ADDENDUM #1

Bid #01-14-15-05 "Westside Middle School Academy Multipurpose Field Project"

Westside Middle School Academy Multipurpose Field Project
Bid No. 01-14-15-05
Project No. 14-28
City of Danbury
Public Works Department

STEEL PIPE BOLLARD

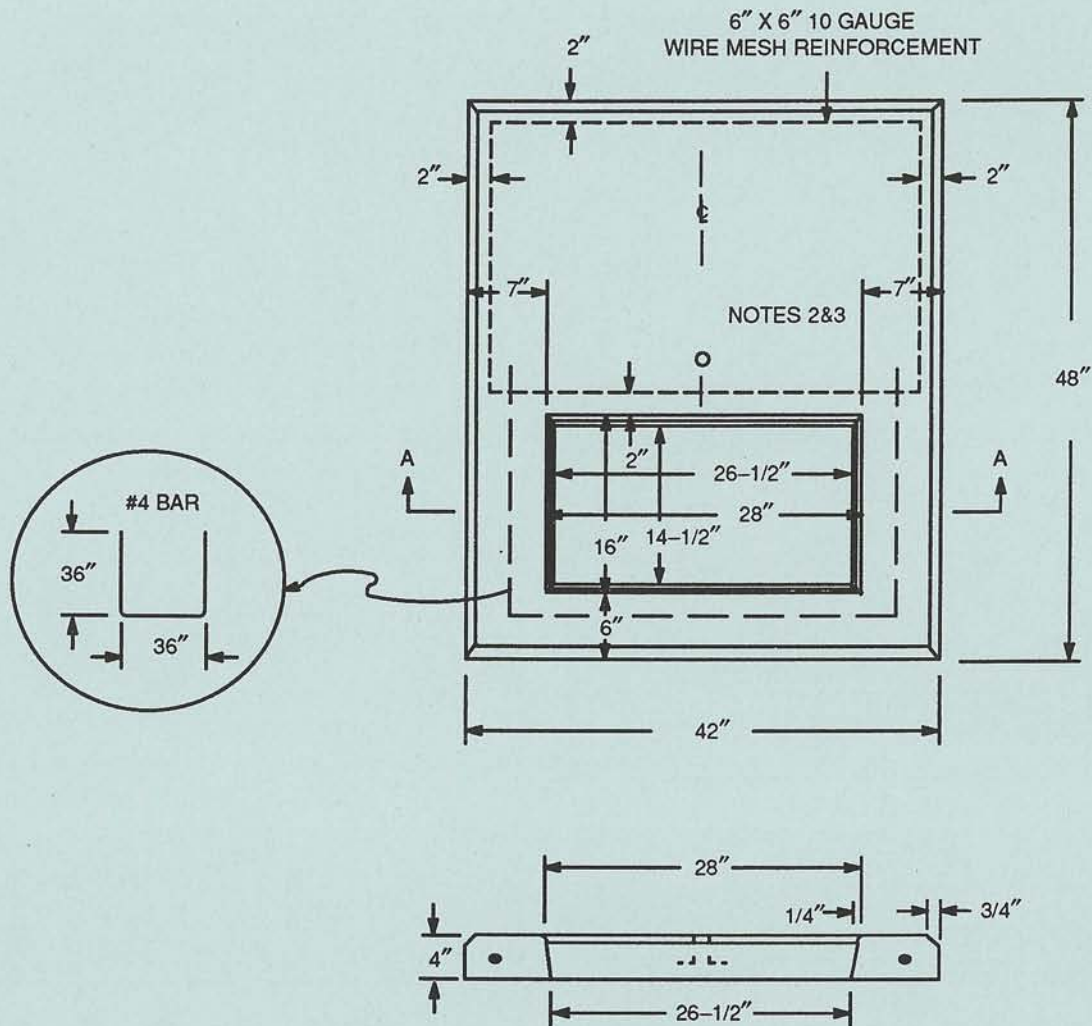
- 1. Drawings are revised to include the attached detail consisting of one page entitled, "Steel Pipe Bollard"
- 2. Drawings are revised to include the attached two-sheet drawing entitled;

1 45" CHAIN LINK FENCE WITH 20 FOOT SAFETY NETTING SYSTEM - TYP.
NTS

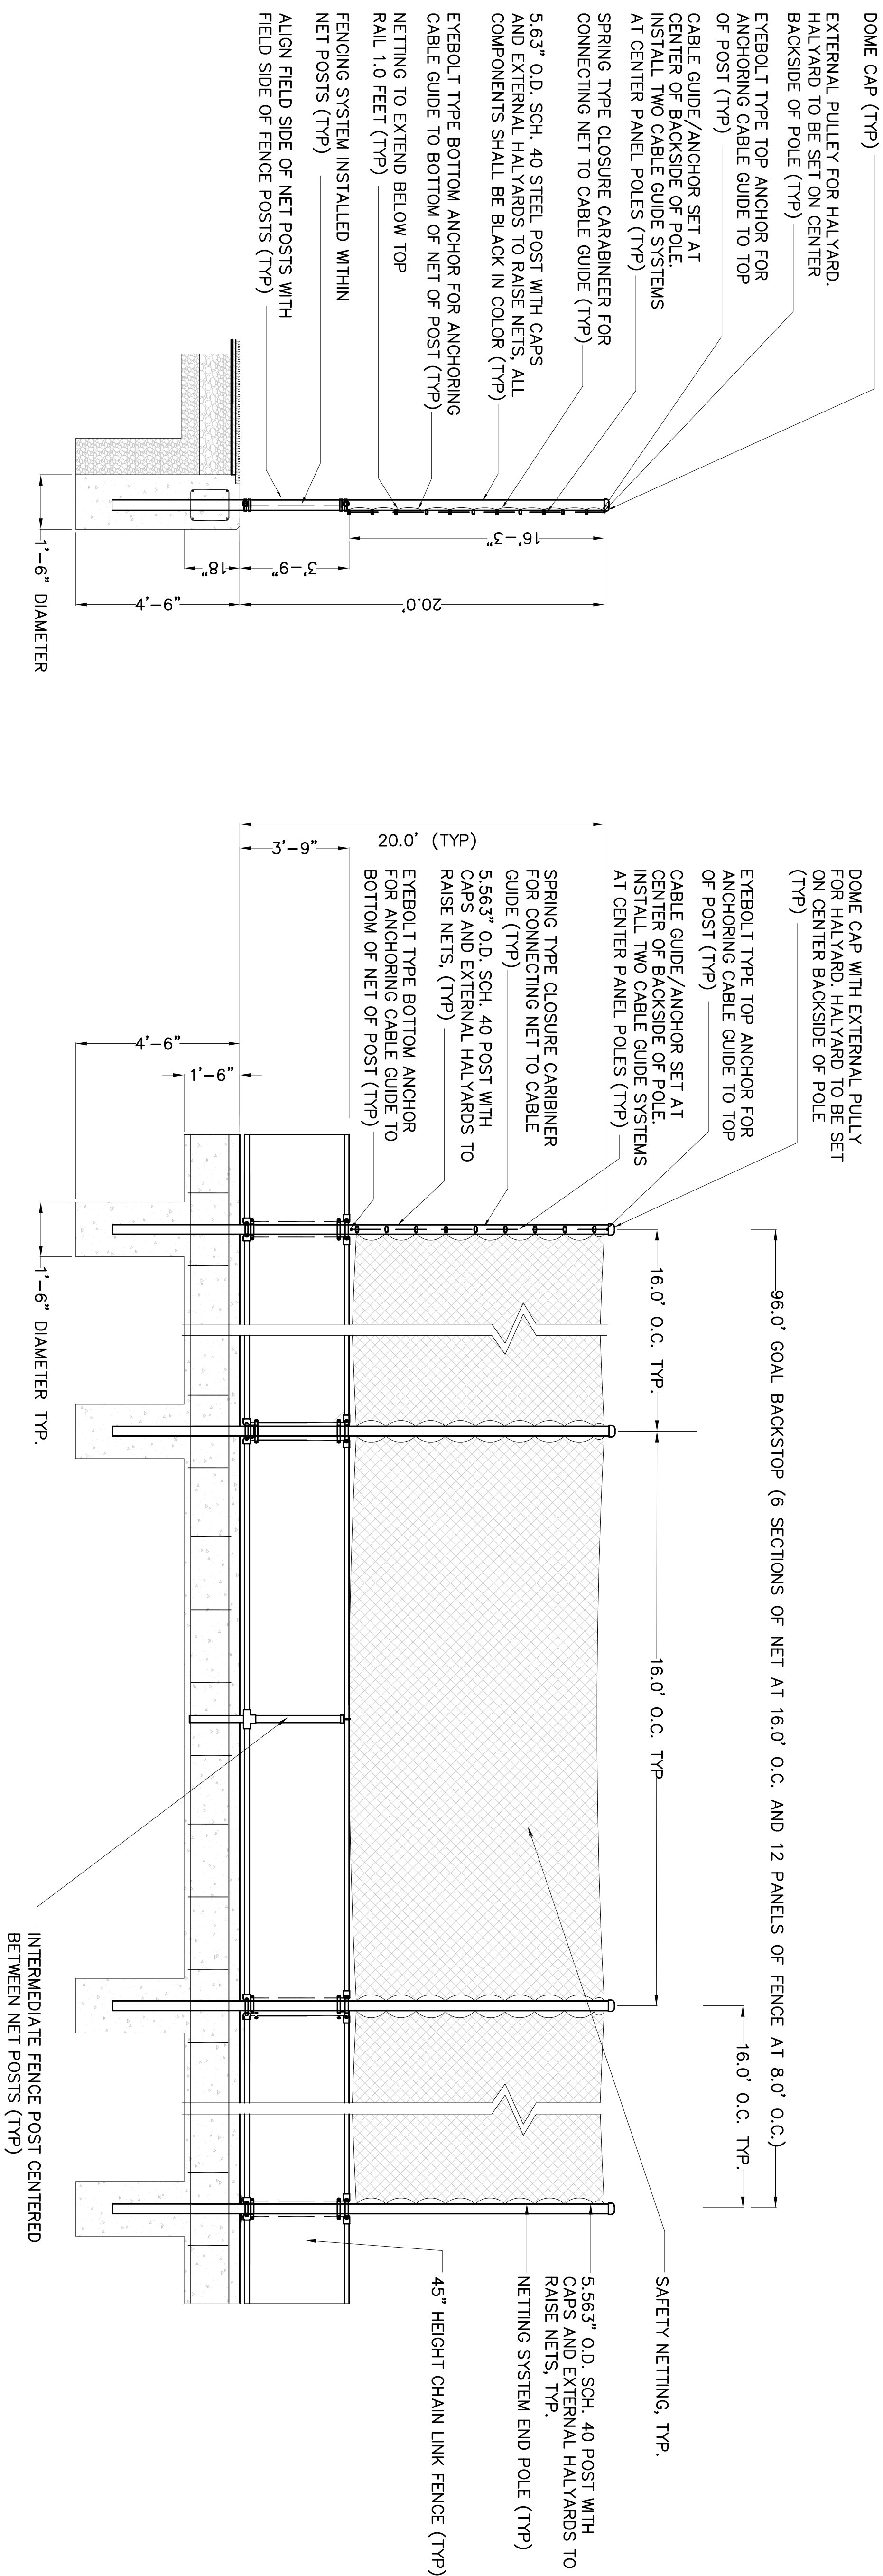
- B. Netting panels for the south side ball control netting system heights shall be factory assembled to match the required 15 foot top height. Extent of netting is identified on the drawings and have a total finish height of 15 feet.

Netting panels for the parking lot side ball control netting shall system heights shall be factory assembled to match the required 16.5 foot height. Extent of netting is identified on the drawings and has a total finish height above the top rail of the fence and overhang 3" below the top rail fence of 16.25 feet. This netting shall site above the 45" chain link fence and extend to a height that is 20 feet above the field level.

- 1. Net posts for the south side ball control netting system shall include ground sleeves and be 15.5 feet in exposed height above finish grade. Ground sleeves shall be 4.30in OD (4.10in ID) with a depth of 48 inches and imbedded in concrete per manufacturer's requirements. End posts footings shall be sized to accommodate larger loading per end of cable conditions.
- 2. Net posts for the parking lot side ball control netting system shall be integral with the chain link fencing system and shall alternate with intermediate fence posts. Posts shall be galvanized steel
